REMARKS

Serial No.: 09/504,631

Attorney Docket No.: 00P07463

Annotated Sheet Showing Changes

Fig. 1 [REDACTED] (Prior Art)

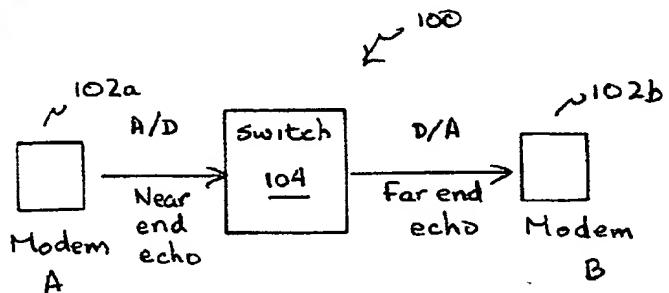
The figures were objected to because of the absence of the label "Prior Art" in FIG. 1. FIG. 1 has been amended to add the label; it is noted, however, that the teachings of the present invention are applicable in a system such as that illustrated in FIG. 1. No new matter has been added.

Upon entry of the instant Amendment, Claims 1-5, 7, and 9-13 are pending. Claims 1, 5, 7, and 9 have been amended, and claim 13 has been added, to more particularly point out Applicants' invention. Claims 6 and 8 have been canceled. Claim 3 has been amended to overcome the Section 112 rejection. The drawings have been amended to obviate the objection to FIG. 1.
